HAP: 281 Grosvenor Street
K. Gonyou

TO:	CHAIR AND MEMBERS LONDON ADVISORY COMMITTEE ON HERITAGE WEDNESDAY DECEMBER 9, 2015
FROM:	JOHN M. FLEMING MANAGING DIRECTOR, PLANNING AND CITY PLANNER
SUBJECT:	HERITAGE ALTERATION PERMIT APPLICATION: M. PEPPER, 281 GROSVENOR STREET

Image 4: Detail of porch flooring (submitted by applicant). Note: not to scale.

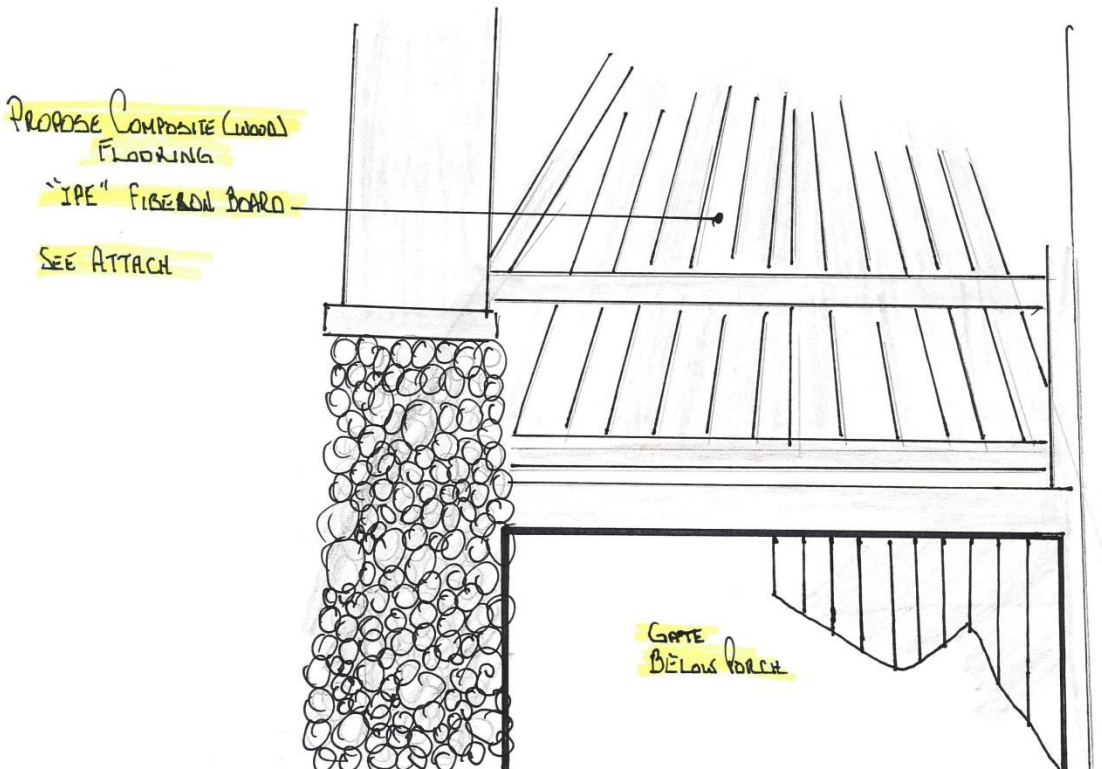
- The proposed "Fiberon Horizon" composite decking be replaced by wood, tongue-and-groove board flooring that is painted or stained. Wood tongue-and-groove board is historically appropriate and compatible with the *Bishop Hellmuth HCD Plan & Guidelines*;
- The field stone veneer be recessed from the field stone piers to provide dimension to the porch skirt. A few inches (~3") would be sufficient to articulate this rhythm;
- The proposed metal spindles be replaced by wooden spindles, approximately 1-3/4" square set apart 3-1/2" on centre, between a wooden top and bottom rail. Wood must be used because the physical goals of the *Bishop Hellmuth HCD Plan* support the replication of historic elements, rather than replacement with new materials with limited historic precedence in the Bishop Hellmuth HCD.

- a. All exposed wood be painted or stained following the appropriate weathering period;
- b. Tongue-and-groove wood be used for the porch floor;
- c. The field stone veneer should be recessed from the field stone piers to provide dimension to the porch skirt;
- d. Wooden spindles be used, approximately 1-3/4" square set apart 3-1/2" on centre, between a wooden top and bottom rail;
- e. Photographic documentation of the alteration and addition be submitted to the Heritage Planner upon completion of the work;
- f. Display of a Heritage Alteration Permit in a location visible from the street until the work is completed.

Image 7: Proposed metal spindles for porch (submitted by applicant).

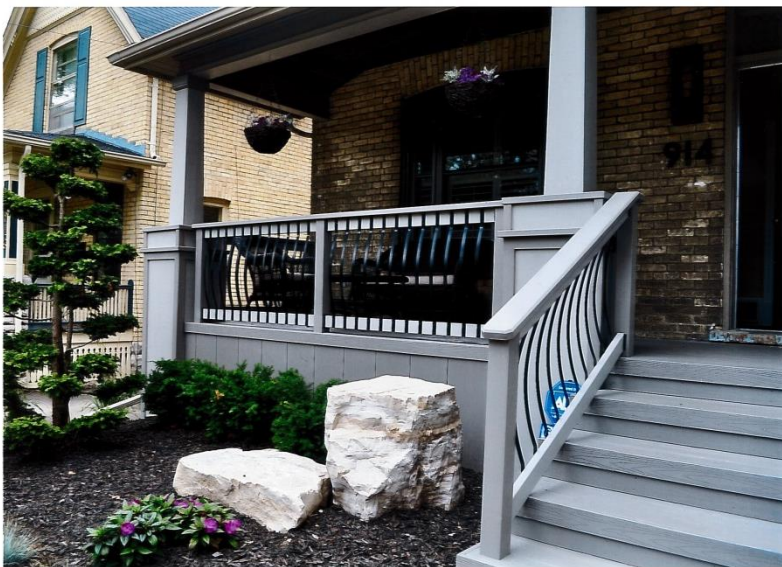
Posts	Posts should be carefully selected and designed to suit the architectural style of the building. Redwood or cedars are preferred woods to use for new posts.	Existing columns have been encased in redwood cedar. Built-up square box columns are identified as typical, and appropriate, post types in the <i>Bishop Hellmuth HCD Guidelines</i> .
Handrails	Handrails and newel posts should match the post style.	The plain handrails, constructed of redwood cedar, are compatible.
Spindles	Traditionally, spindles were 1-3/4" square and 3-1/2" apart between centres. Frequently new spindles are thinner and further apart. This should be avoided as the rail looks weak and light-weight.	Metal spindles are proposed. This material is not compatible, and should be replaced by 1-3/4" square spindles set 3-1/2" apart between centres, set between a wooden top and bottom rail, noting the previous spindles were wood.
